Access Compliance Report

Public Rights-of-Way

(Curb Ramps)

Intersection ID: 10431	Main Street: ASHLEY_RD	Cross Street: SCOTT_FUTRELL_DR	Location: NW
ADA ID: AE5295B4D87A	Ramp Type: Perp	Initial Pass/Fail: Fail	Overall Compliance: No
Severity Score: 12.5			
Codes/Mitigation Info/Possible Solution		Field Measurements/Component Compliance

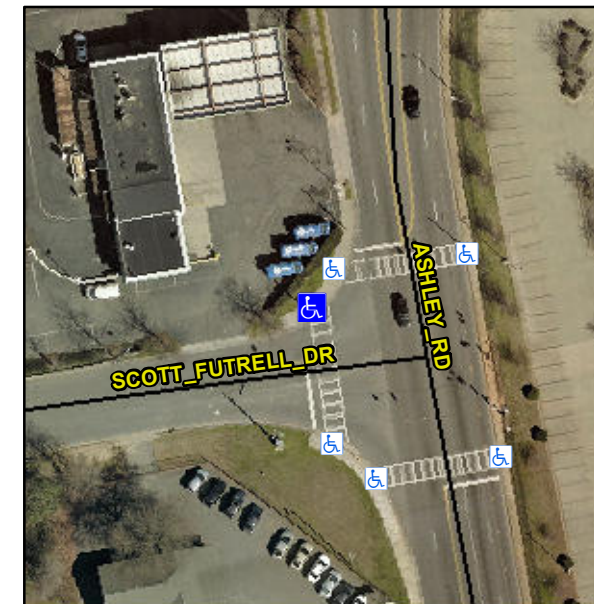
R304.2.2

Compliance	Description	Data	Compliance	Description	Data
N/A	Ramp Length (in)	83.5	No	Ramp Slope (%)	9.2
Yes	Ramp Width (in)	48.0	Yes	Ramp XSlope (%)	0.1
N/A	Flare Type LT	N/A	N/A	Flare Type RT	N/A
N/A	Flare Slope LT (%)	N/A	N/A	Flare Slope RT (%)	N/A
N/A	Flare Traversable LT?	N/A	N/A	Flare Traversable RT?	N/A
N/A	Landing Length (in)	N/A	N/A	DWS Provided?	N/A
N/A	Landing Width (in)	N/A	N/A	DWS Contrast?	N/A
N/A	Landing Slope (%)	N/A	N/A	DWS Length (in)	N/A
N/A	Landing X Slope (%)	N/A	N/A	DWS Full Width?	N/A
N/A	Landing Curb? (Y/N)	N/A	N/A	DWS Offset (in)	N/A
N/A	Shared Landing?	N/A			
N/A	Gutter Ponding?	N/A	N/A	Gutter Slope (%)	N/A
N/A	Gutter Lip Ht (in)	N/A	N/A	Gutter X Slope (%)	N/A
N/A	Painted X Walk1?	Yes	N/A	Painted X Walk2?	N/A
	X Walk 1 Direction	To S		X Walk 2 Direction	N/A
N/A	X Walk 1 Width (in)	114.0	N/A	X Walk 2 Width (in)	N/A
	X Walk 1 Slope (%)	5.0		X Walk 2 Slope (%)	N/A
	X Walk 1 X Slope (%)	2.7		X Walk 2 X Slope (%)	N/A

Remove & Replace Entire Ramp.
